Response to Submissions

Samuel Gilbert Public School Redevelopment
SSD18_9274

Submitted to Department of Planning and
Environment
On behalf of Schools Infrastructure NSW

13 May 2019 | 2190298

Figure 4 Reduced height of Building N and Building P – previous design (left), revised design (right)

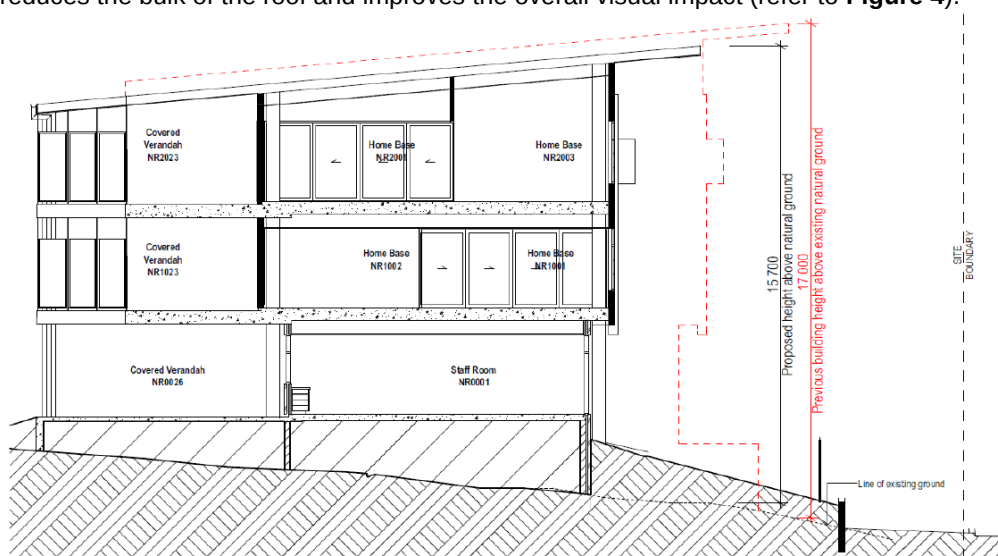
The Department, Council and the Government Architect NSW (GANSW) raised concern about the appropriateness of the scale of the proposed building on Ridgescrop Drive and the existing character of the site. The Department

requested consideration be given to increasing the set back of Building N and to allow for additional screen planting. In addition to this, a Clause 4.6 Variation was requested to be submitted.

The reduction in height has allowed for the reconfiguration of the roof design of Building N and Building P, which reduces the bulk of the roof and improves the overall visual impact (refer to **Figure 4**).

Figure 8 Additional kiss and drop zones (shown in red)

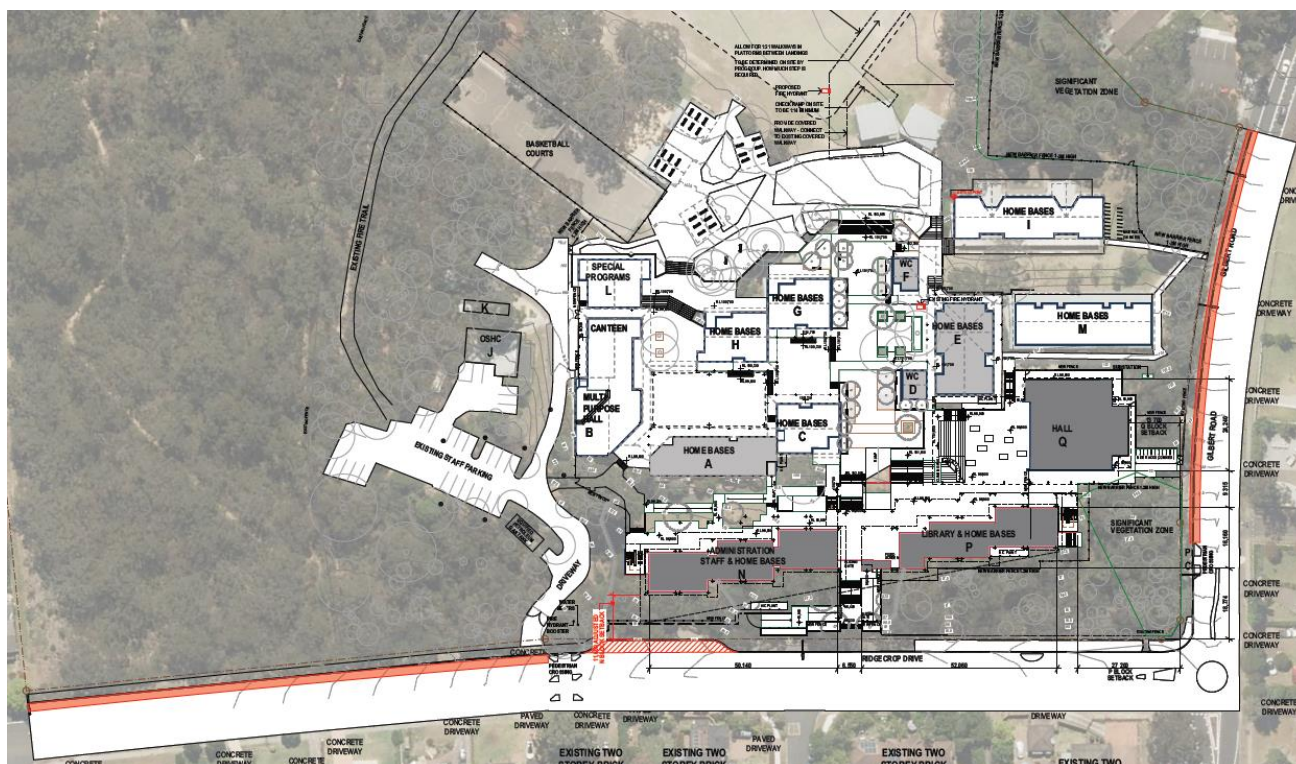
Traffic and parking issues were primarily raised by Council and TfNSW and focussed on:

- Trip generation assumptions and intersection performance analysis.
- Drop-off/pick-up arrangements and the potential to introduce a kiss and ride zone.
- Car parking provision is less than the rates set out in The Hills Development Control Plan (THDCP) and relies on public and on-street parking facilities.
- Safety of the school entrance.

Additional kiss and ride zones are proposed to be provided along Ridgeway Drive and Gilbert Road (refer to **Figure 8**). These zones will be sign-posted to designate this area as a loading zone during the AM and PM peak periods. Based on trip generation for the proposed development, a kiss and ride zone of approximately 220m – 230m is required to cater for demand. The two additional kiss and ride zones are a total of 272m in length. In addition to this, the existing indented kiss and drop bay on Ridgeway Drive will be reinstated, resulting in more than sufficient capacity for loading.
